Re: Formal Dispute Resolution - Statement of Position
Motor Wheel Disposal Site

Settling Defendants - Statement of Position Motor Wheel Disposal Site - May 11, 1999

Project Reference: #5104
MOTOR WHEEL SITE DISPOSAL SITE CLOSURE
LANSING, MICHIGAN

Figure 1. Near zero gradients in the vicinity of the stagnation point

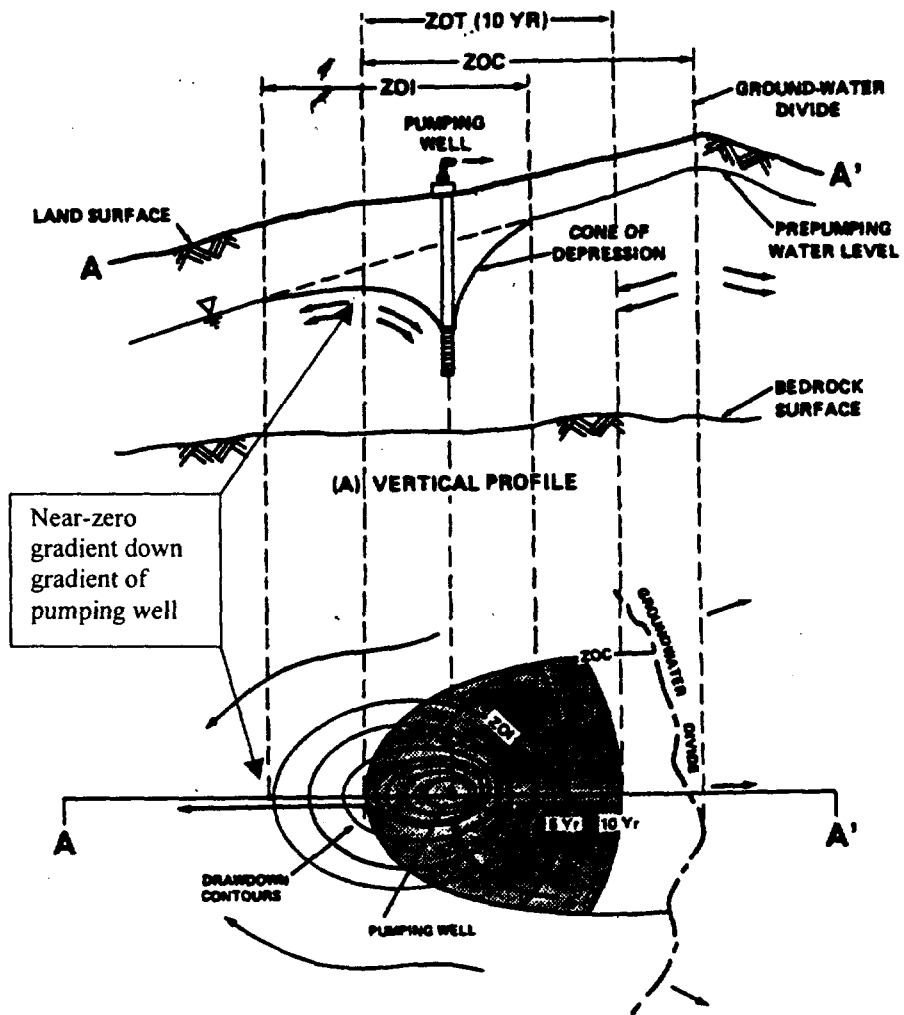
The range of times required for plume separation ranged from 3 to 11 years reflecting the time required for initial concentrations to migrate downgradient of the Zone 1 stagnation point. Migration downgradient of the Zone 1 stagnation point is reduced relative to ambient groundwater flow due to the near zero hydraulic gradient at that location (see Figure 1).

Figure 8

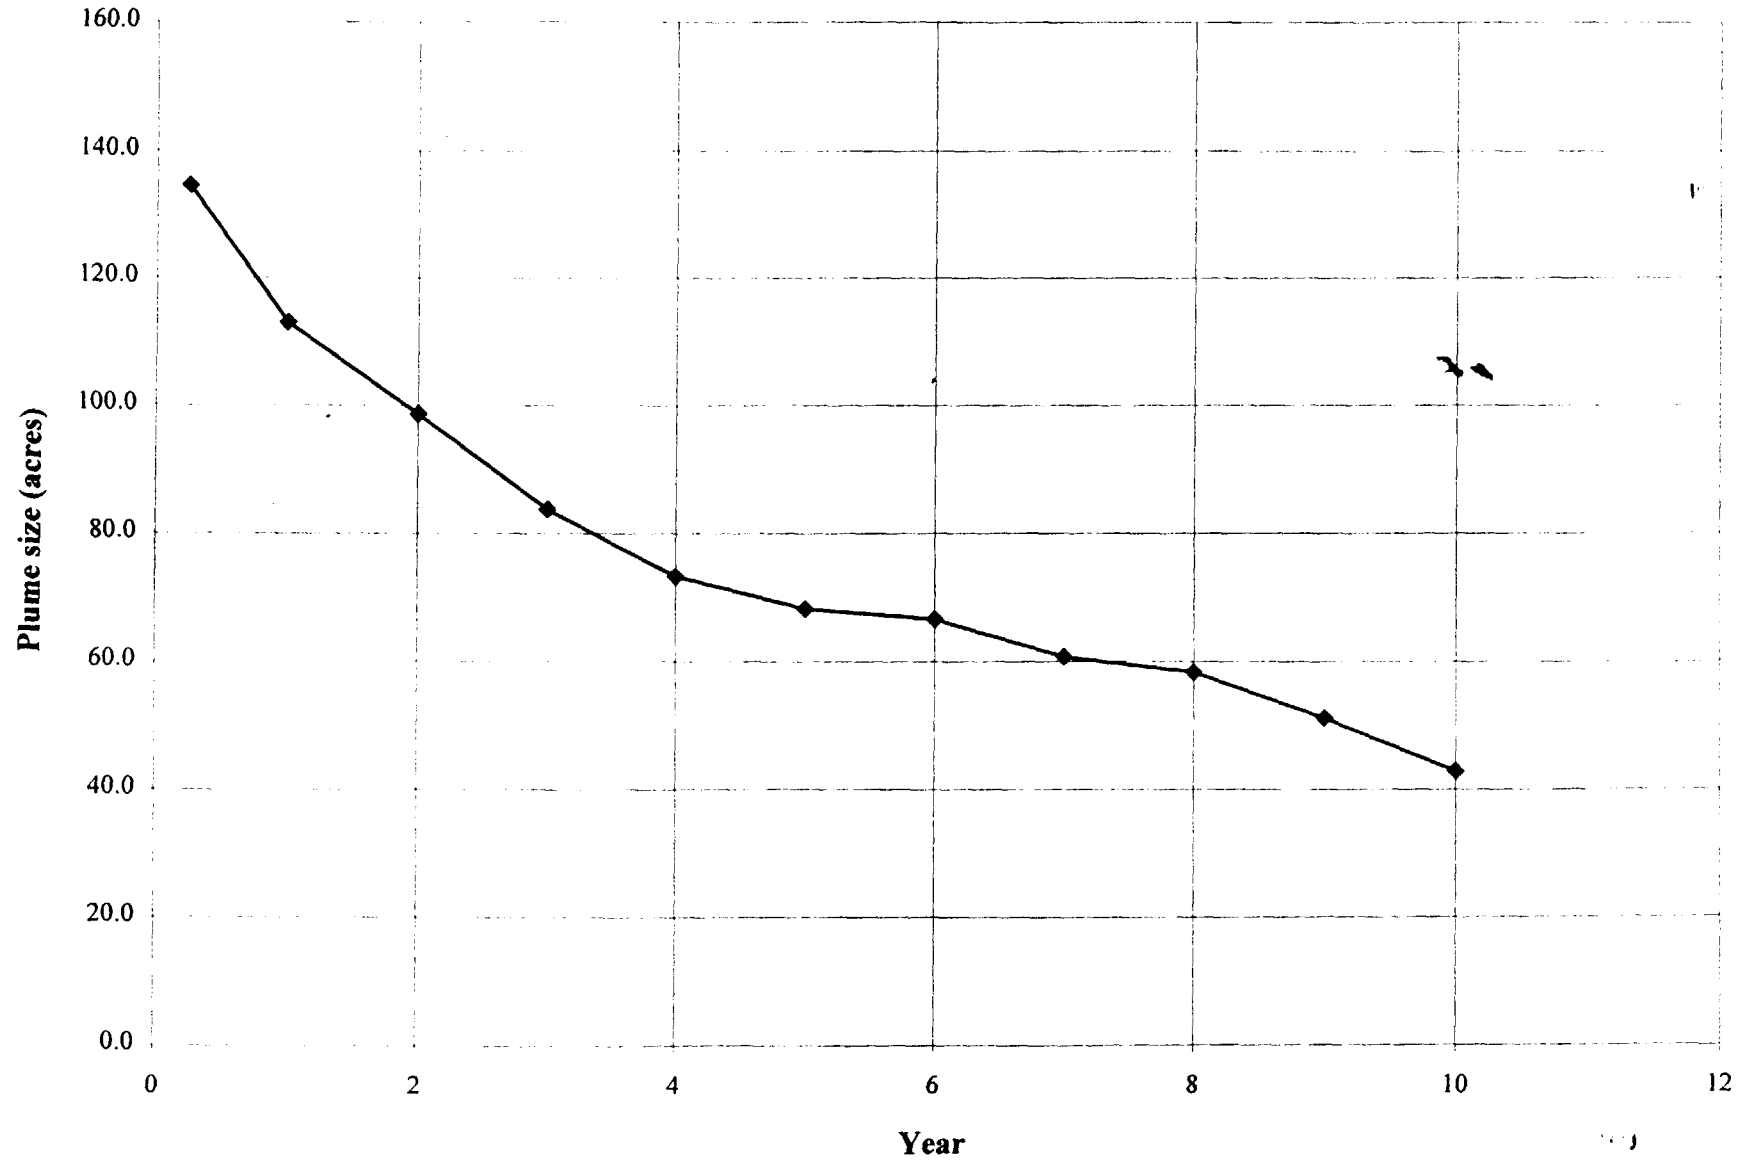
Figure 8 shows the change in plume area over time for the MWDS Summer Pumping Plan. This graph indicates that there is no increase in the plume size.

Figure 1: Figure 11 from (Luukkonen, C.L., et al., 1998) with Projected MDNR Statewide Groundwater Database Water Levels

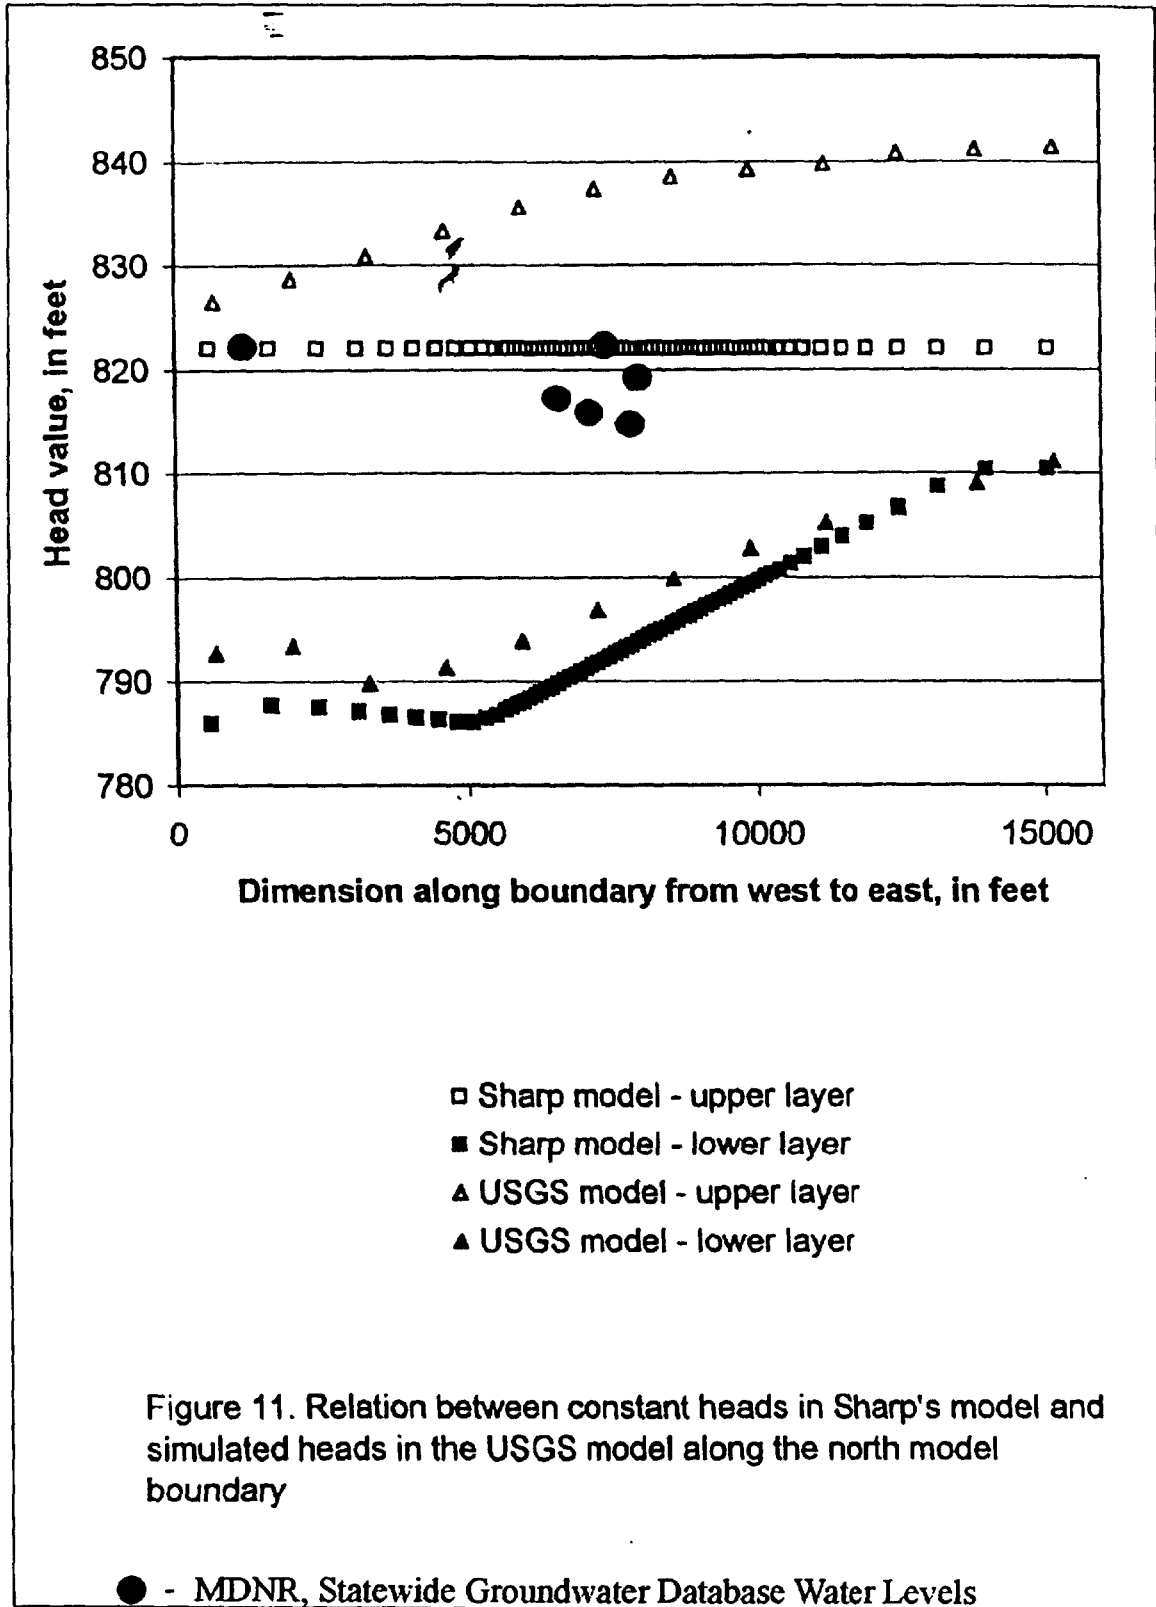
The USGS report also discussed the variation in constant head boundaries within the Glacial Aquifer. At the northern end of the Sharp model the head values calculated in the USGS tri-county model varied in elevation from high in the east to lower in the west (see Figure 1). The values used in the Sharp model were based on observed water levels for the area (see Figures 1 and 2) and are closer to observed values than those calculated in the USGS tri-county model.

Figure 3: Figure 14 from (Luukkonen, C.L., et al., 1998) with Projected MDNR Statewide Groundwater Database Water Levels

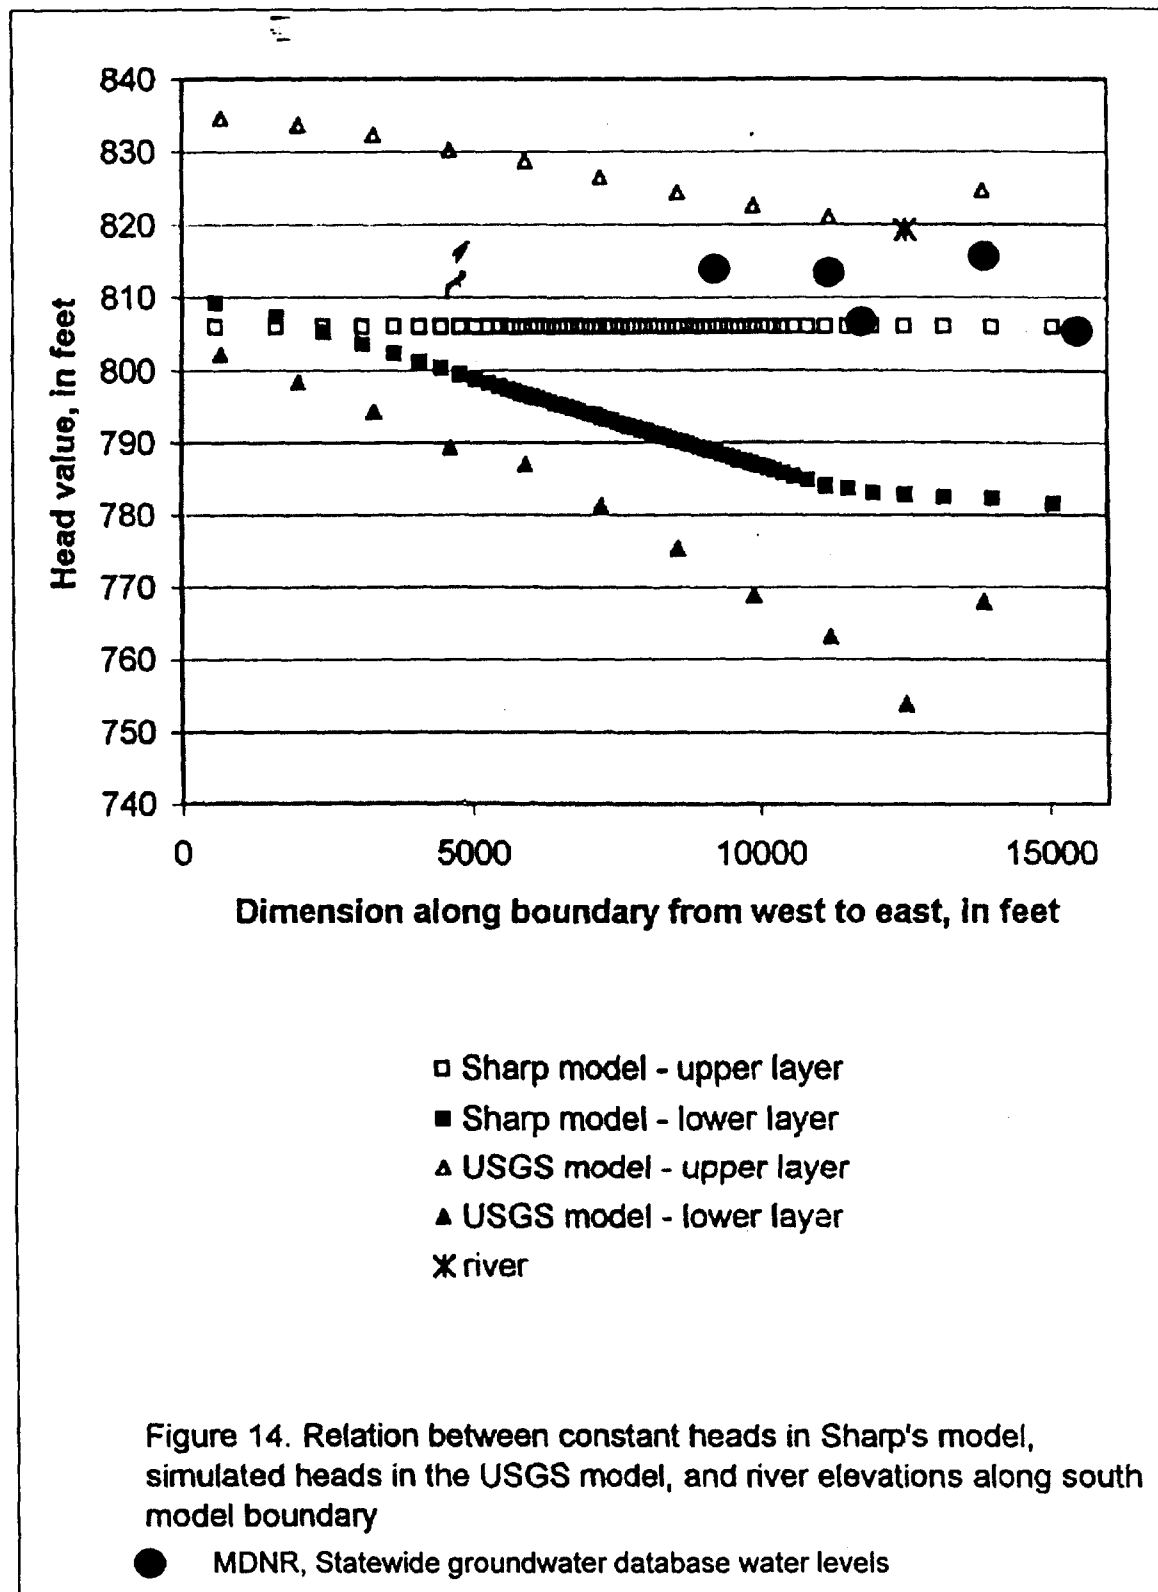
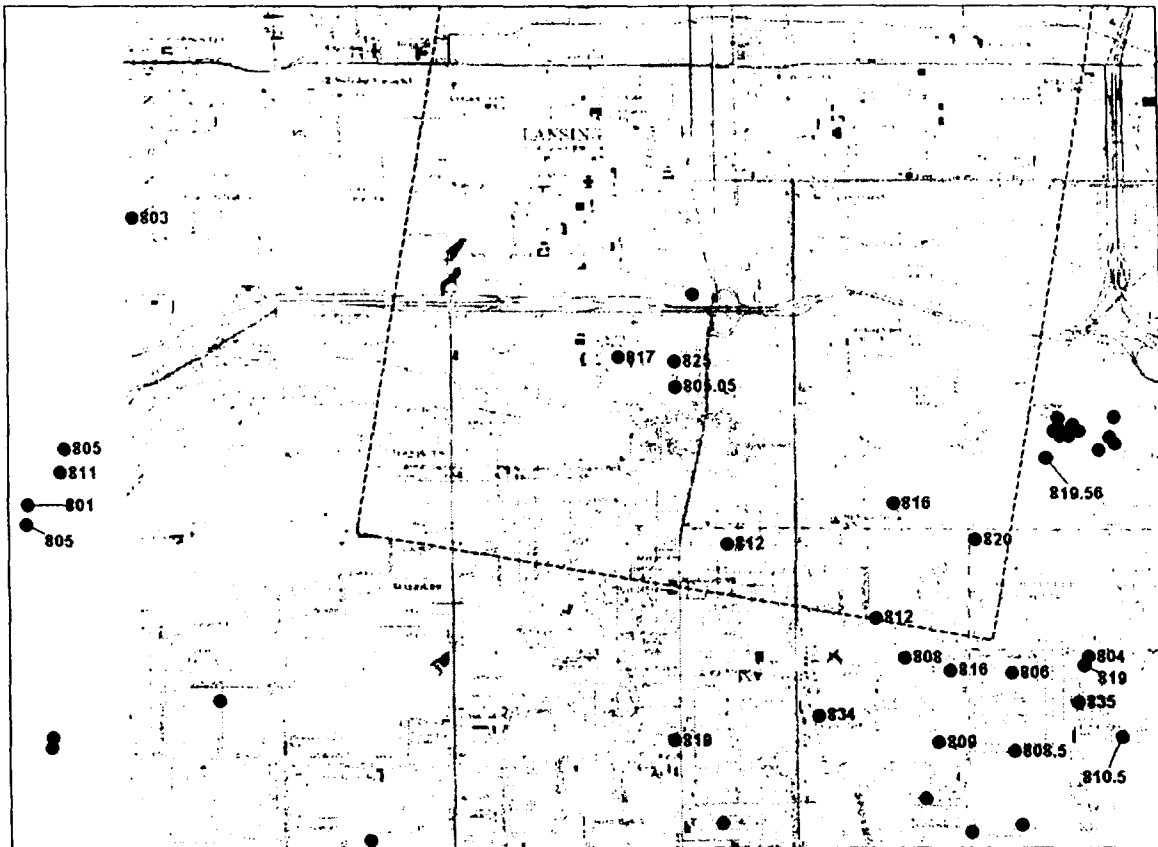
For the southern boundary of the model within the Glacial Aquifer, the USGS tri-county model predicted water level elevations above the Grand River stage (see Figure 3). Conversely, observed water levels near this area show that the actual values are closer to those utilized in the Sharp model, than those predicted by the USGS tri-county model (see Figure 4).

Figure 5: Comparison of site specific water levels with the Grand River stage from the USGS Tri-county model (1996)

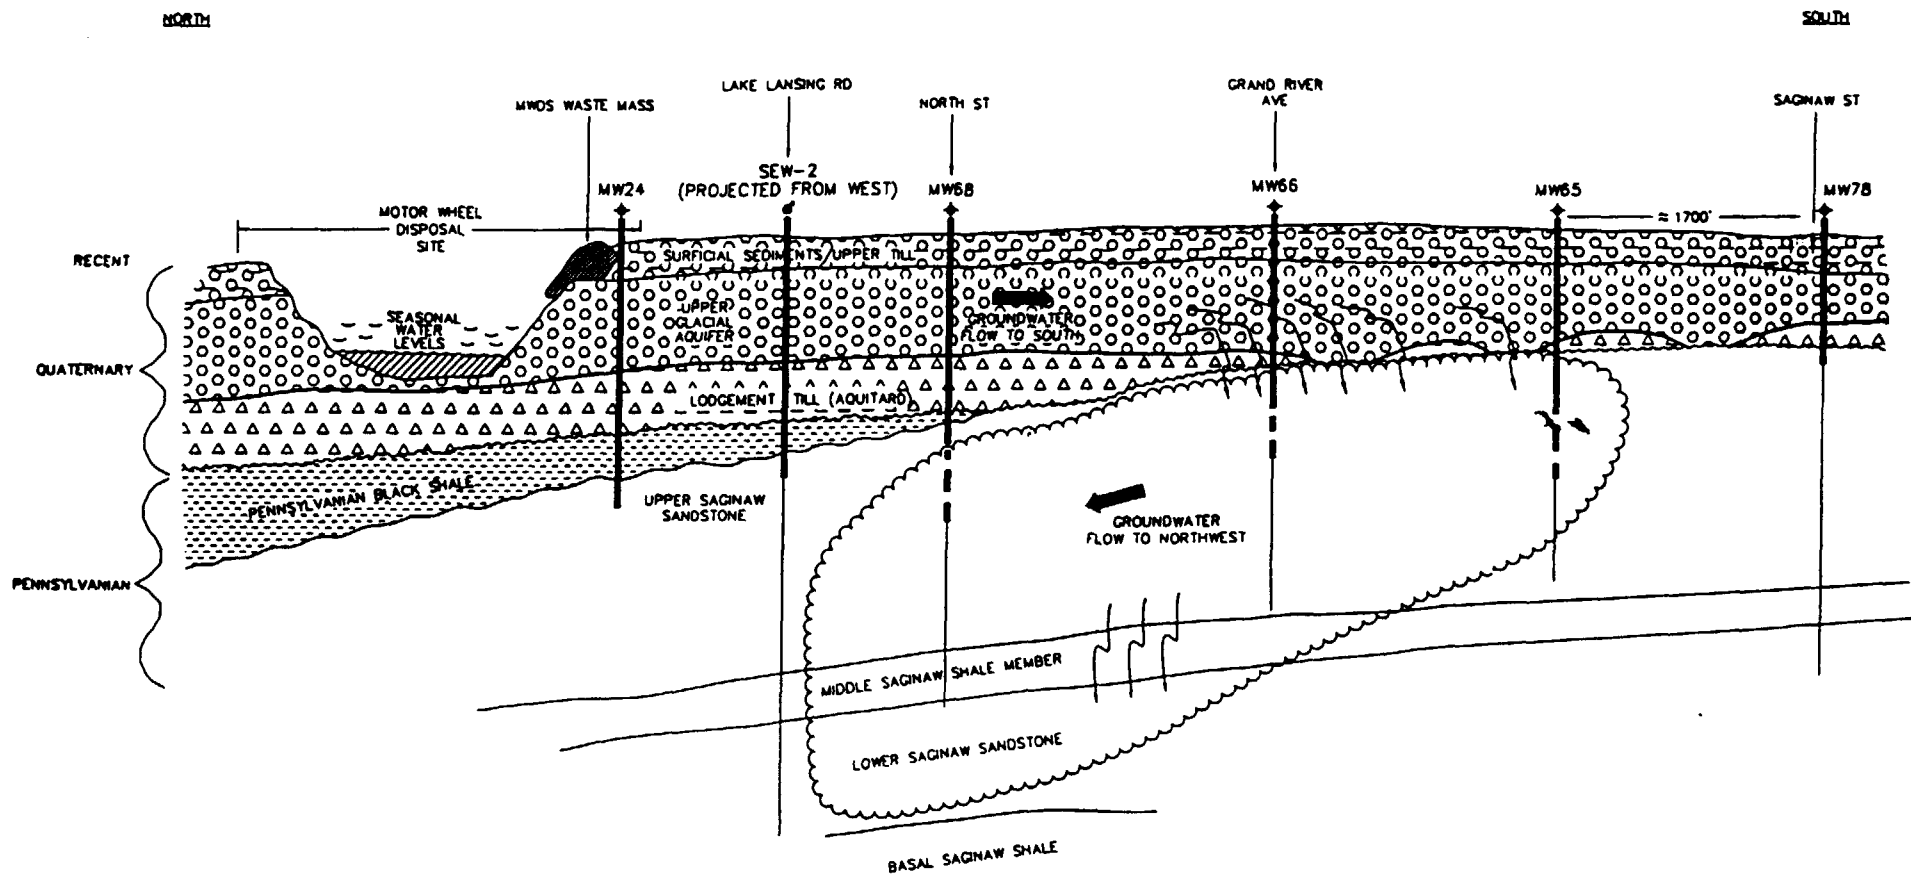
In addition, river elevations along the Grand and Red Cedar Rivers are higher than groundwater levels in the underlying aquifers (see Figure 5), indicating that these rivers lose water to the underlying aquifer (losing streams). Available streamflow data (from Holtschlag et al., 1996) also suggests that this portion of the Grand River loses a considerable amount of water to the underlying aquifer (see Table 1).

Figure 7: Effect of incorrect injection well in Sharp Saginaw model

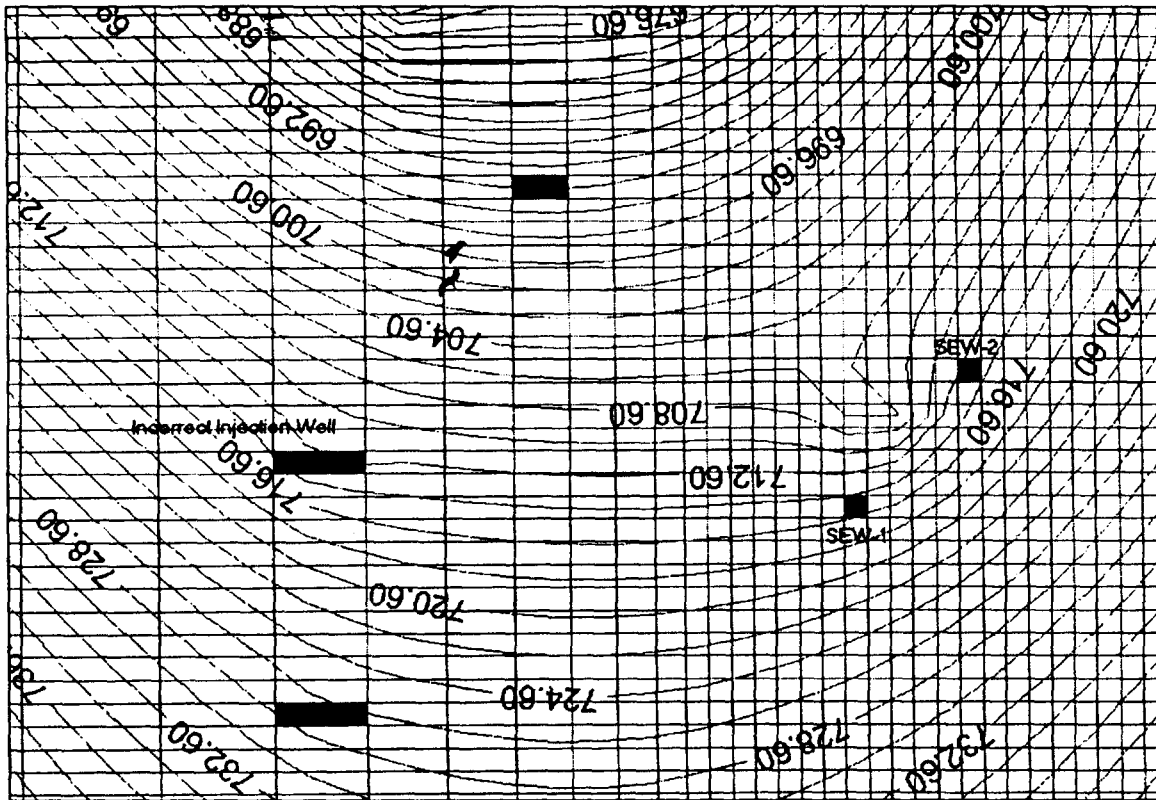
We recognize the error and it has been corrected. The location of the well was far enough away from the capture zones developed by SEW-1 and SEW-2 that flow and transport predictions of the contaminant plume were not impacted by the mistake. Model results show that there is very little influence (i.e. no mounding) by this particular well on the hydraulic head distribution in the surrounding Saginaw Aquifer (see attached Figure 7), indicating that there would not be an effect on the SEW-1 / SEW-2 capture zones.
